Department of Public Works/Engineering
MAJOR DEVELOPMENT REVIEW TEAM
PO Box 1307, Issaquah, WA 98027-1307
425/837-3444 Fax: 425/837-3439

URBAN VILLAGE DEVELOPMENT COMMISSION AGENDA

Request: Application for approval of a preliminary plat for Division 95 of Issaquah Highlands, to subdivide 3.54 acres into 38 residential lots and 4 tracts for open space, pedestrian and vehicular access, a trail, and utilities.

Woonerfs

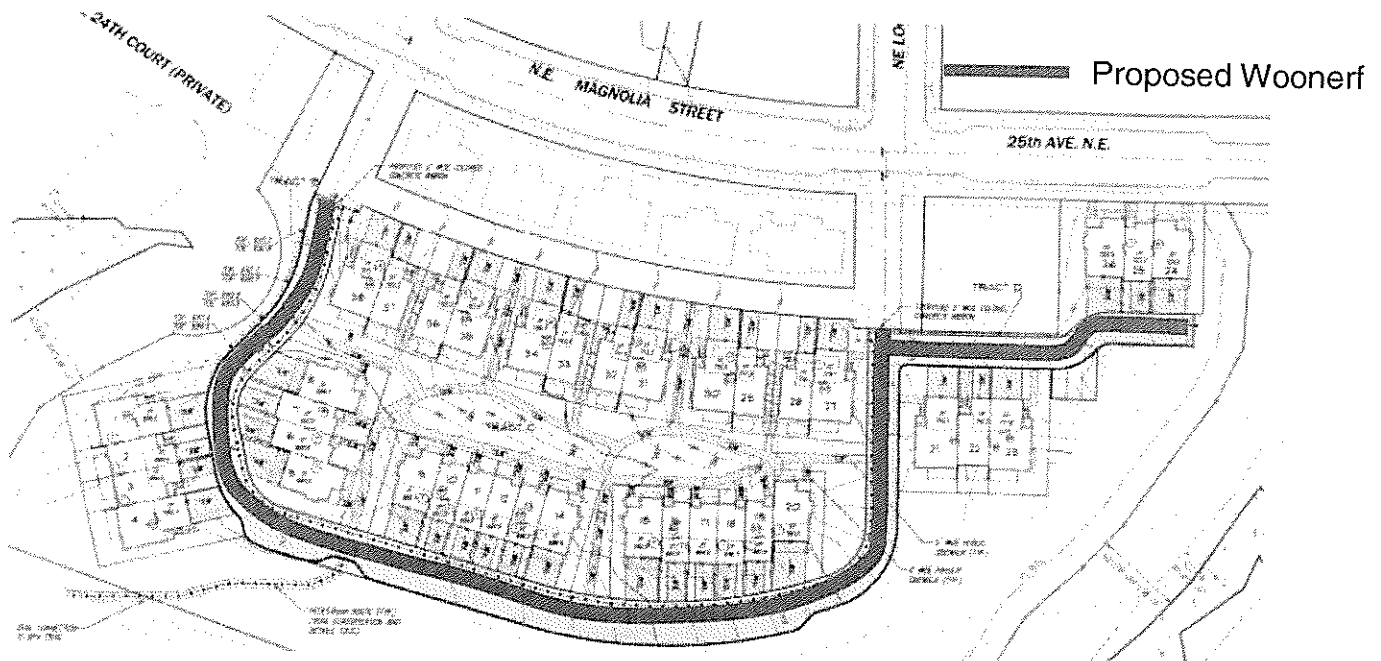
All of the proposed vehicular access is provided by woonerfs, except for the existing alley behind Lots 27-38. Woonerfs will furnish both pedestrian and vehicular circulation with a shared, non-asphalt surface. Though this discussion is provided under Appendix H, Roads, there are no specific dimensional standards for woonerfs, only general ones, which are discussed under Appendix U, Parks, Plazas, and Woonerfs; however, since they provide all proposed vehicular access they are reviewed here.

Woonerfs are designed and approved on a case by case basis. To ensure Eastside Fire and Rescue (EF&R) access to the homes, there are certain minimum width constraints that must be applied. That is, woonerfs that provide through traffic must be at least 18 ft wide and they additionally may have 7 ft of parallel parking. And street trees shall be provided along the woonerf to further enhance its character. [Condition 21]

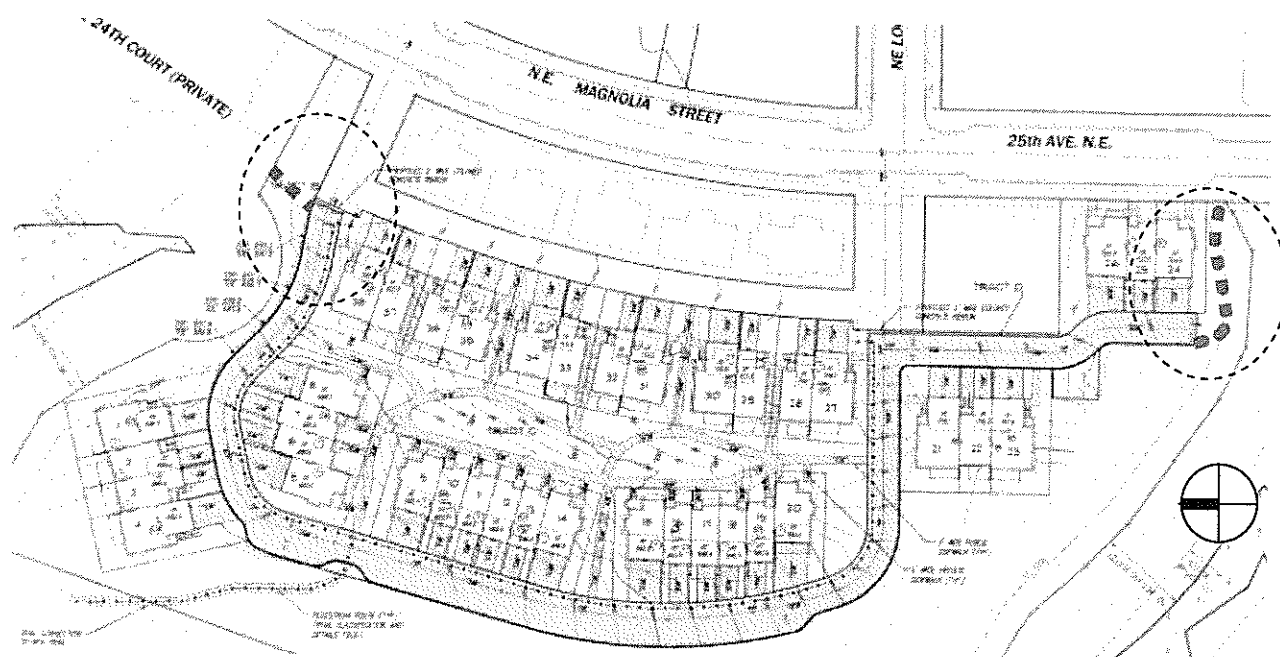
With regard to external connections: the plat does not have vehicular connectivity with adjacent properties, but the applicant has proposed an external pedestrian connection to the BPA, which is discussed under the Section on Trails in Appendix T below. Furthermore, the sidewalks associated with the streets leading to this plat, directly connect it to important external pedestrian routes. There are two locations in which deadend pedestrian routes at each end of the plat should be addressed.

On the southern edge, by Lot 24, the woonerf ends. There is property available to provide a connection to 25th Ave, such as a Neighborhood Walk, adding to the pedestrian connectivity especially for Lots 21-23. Likewise, the internal circulation of Division 96 to the north, ends at Tract B. Another Neighborhood Walk could be provided here to also improve pedestrian connectivity. Without this connection, a pedestrian would have to walk to Natalie Way to connect between Divisions 96 and 95; however, the improvements in Division 96 do not meet Tract B so this connection is just strongly encouraged. See Appendix T, Trails, below for additional information regarding Neighborhood Walks. These additional connections are consistent with the following guideline: "The use of cul-de-sacs and similar 'dead-end' neighborhood streets should be reserved for special situations such as topographical considerations, open space access points, and development adjacent to limited access roadways. When used, they should provide pedestrian connections to other parts of the Grand Ridge community or into nearby natural areas." [Condition 29]

Lot Design

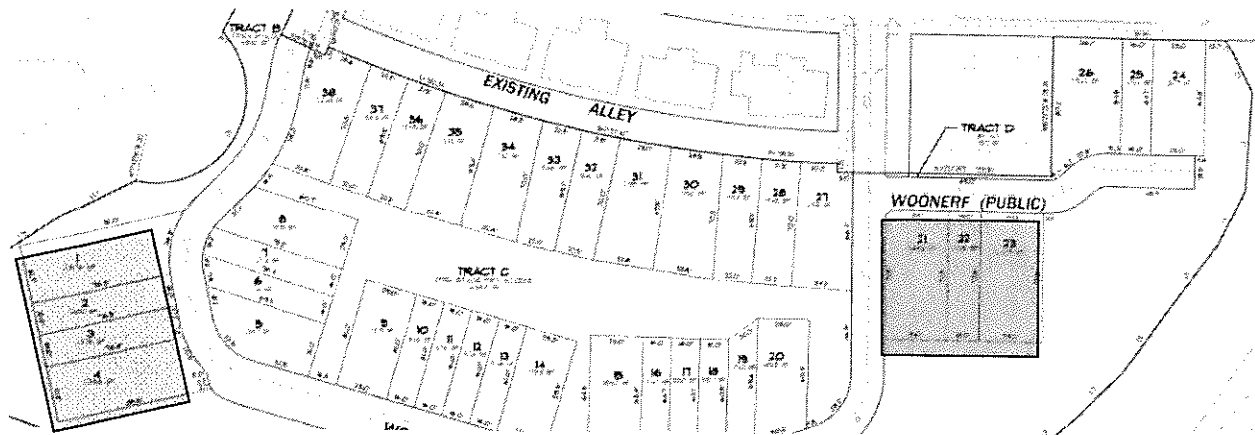
The Development Agreement places importance on creating a pedestrian friendly and socially gregarious public realm in which houses address the street and auto dominance is reduced. The design of narrow, front loaded lots (Lots 1-4 and 21-23 – see plan below for location) increases the frequency of vehicular/pedestrian conflicts and potentially diminishes the relationship between the house and the street as well as diminishing the pedestrian dominance expected of a woonerf. It is necessary to limit the width of the on-site driveways to ensure the residences have a strong relationship with the street, "...where the whole composition of streets, trees, parkways, walks, front yards and front porches define and contain a common space for residents to stroll, meet, play, and socialize." [Condition 30]

Service and Mechanical Area Screening

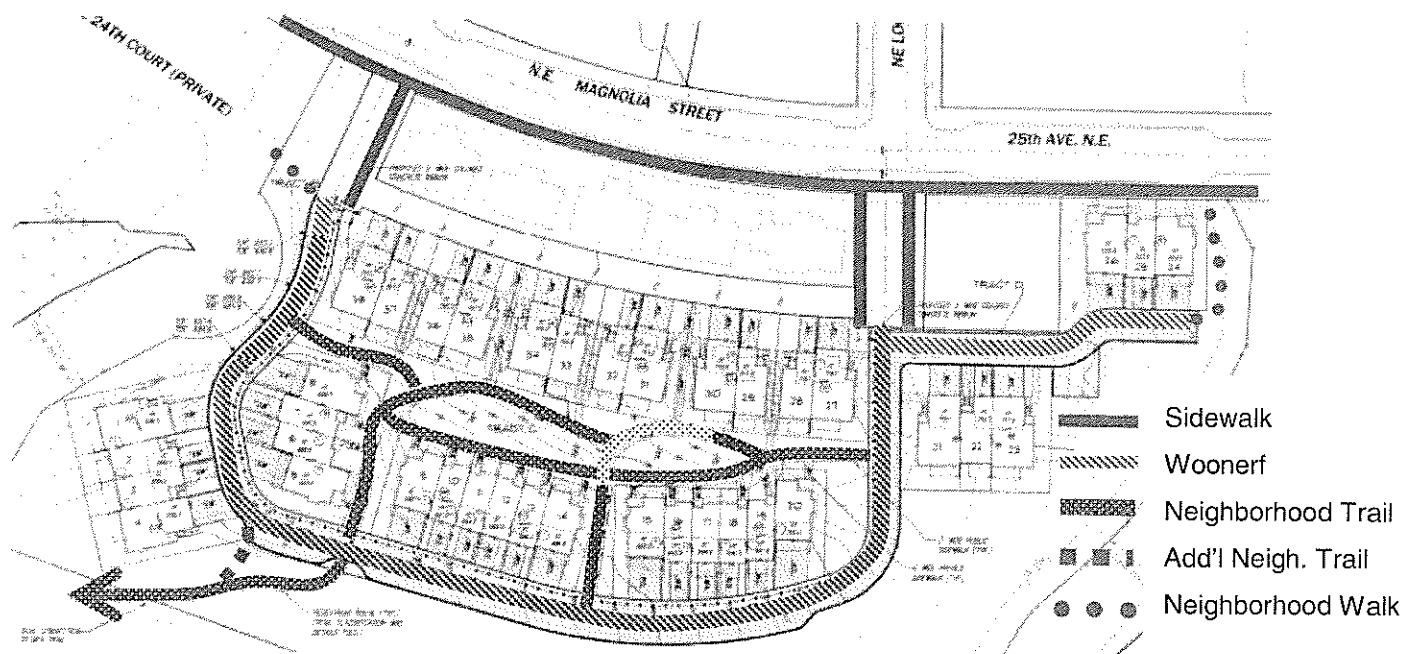
Access and equipment associated with wet and dry utilities are a necessary part of a functioning community. However, their presence does not enhance the overall residential character and objectives. Screening and location can reduce the impact of these necessary elements. [Condition 36]

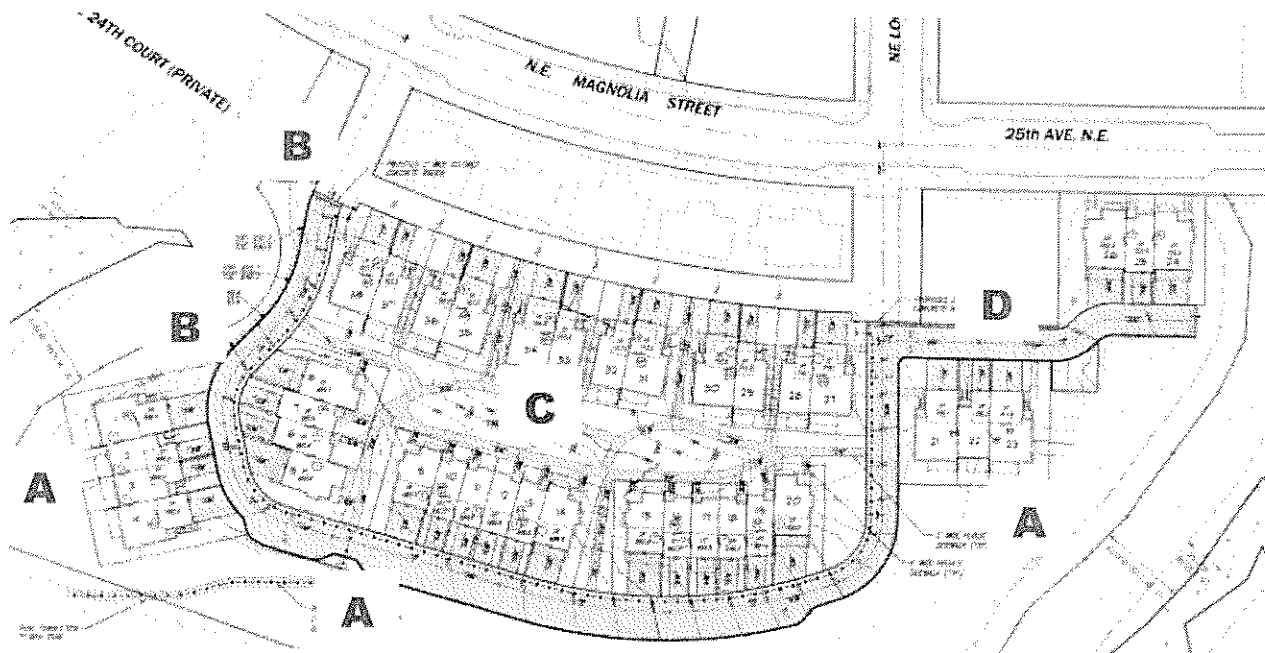
Most of the trails shown will be Neighborhood Trails, which are 6 ft wide with 4 ft planted borders on each side. Neighborhood Trails interconnect the sidewalk/woonerf system and stand in for sidewalks/pedestrianways where streets/woonerfs are not provided, such as throughout Tract C. Neighborhood Trail's surface materials shall be concrete or pavers (not asphalt or gravel) consistent with the Neighborhood Type. Paths are generally optional but should be a minimum of 5 ft wide where they serve the site or a minimum of 4 ft wide if they serve individual or two residences. [Condition 37]

Neighborhood Walks are short, small-scale walkways designed to provide recreational opportunities, alternative routes, or shortcuts. They are appropriate to provide pedestrian connectivity from deadend vehicular facilities. The walk is a 4 ft wide trail with 3 ft landscape borders which should fit in these locations.
